CHANGE ORDER

No. 2-01

PROJECT:	2022 Capital Outlay Project	DATE OF ISSUANCE:	April 20, 2022
OWNER:	Ogdensburg City School District 1100 State Street Ogdensburg, New York 13669	ENGINEER:	BCA Architects & Engineers 15 Public Square Watertown, New York 13601
CONTRACTOR: (Name, Address)	Continental Construction, LLC P.O. Box 358, 2125 State Hwy 812 Gouverneur, NY 13642	ENGINEER'S PROJECT NO.:	2022-013
CONTRACT FOR:	No. 2 - General Construction	SED PROJ. MGR.:	Wendy Clark
CONTRACT DATE:	August 22, 2022	SED CONTROL NO.:	51-23-00-01-0-006-013 John F. Kennedy

Add to replace deteriorated entrance mat within Vestibule V006 & broadloom carpet in adjacent Corridor C108. \$ 32,364.41

1 PARTIAL FLOOR PLAN - AREA C

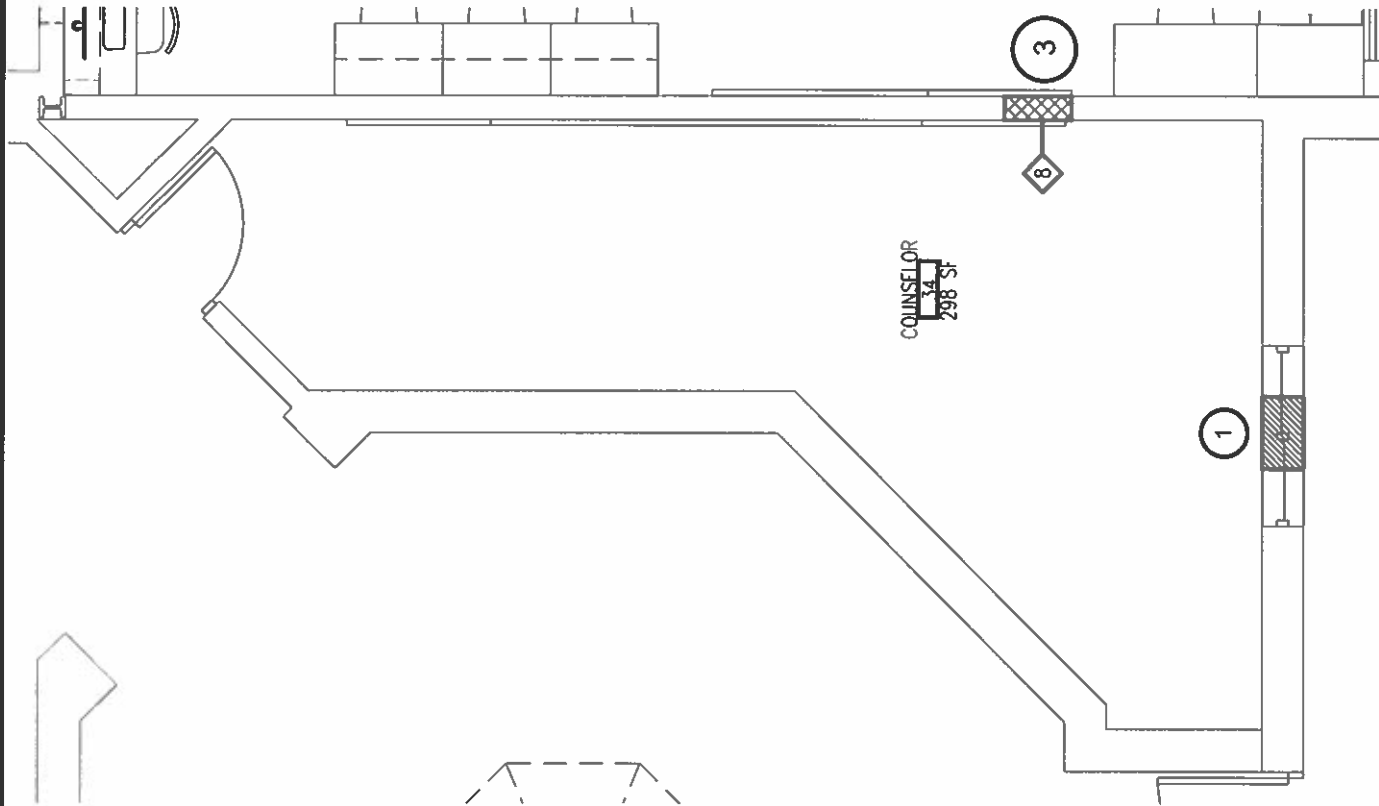
1. Remove existing rubber tile flooring within Vestibule V006. Prepare substrate and provide Milliken Obex Bar CutX walk off matt system.
 - a. Surface application with perimeter trim per manufacturer.
 - b. Provide transition from corridor carpet per manufacturer.
 - c. Cut to fit entire vestibule.
 - d. Color "Dark Grey"
2. Remove existing carpet flooring from corridor C108. Prepare/skim substrate and provide Milliken Formwork carpet floor finish.
 - a. Existing ceramic tile wall base to remain.
 - b. Broadloom roll goods.
 - b. Provide transition at doorways, up to rubber tile flooring within Corridor 108, and up to existing carpet to remain within Corridor C107 (beneath corridor doors).
 - c. Color "Plinth"

- 1 PROVIDE 1/8-INCH GALVANIZED STEEL PLATE OVER EXISTING LOUVER UPON REMOVAL OF HVAC EQUIPMENT BY MECHANICAL CONTRACTOR. PROVIDE SPRAY FOAM INSULATION AND CONCRETE BLOCK ON INTERIOR. PRIME & FINISH PAINT TO MATCH EXISTING WALLS. SEE DETAIL '4' ON SHEET A100
- 2 RESIZE EXISTING 3'-0"H x 6'-6"L OPENING TO FIT NEW 26"x26" SUPPLY AIR DUCT.
- 3 INFILL FORMER AIR TRANSFER OPENING THRU WALL. PATCH & MATCH ALL DISTURBED SURFACES. PRIME & FINISH PAINT.
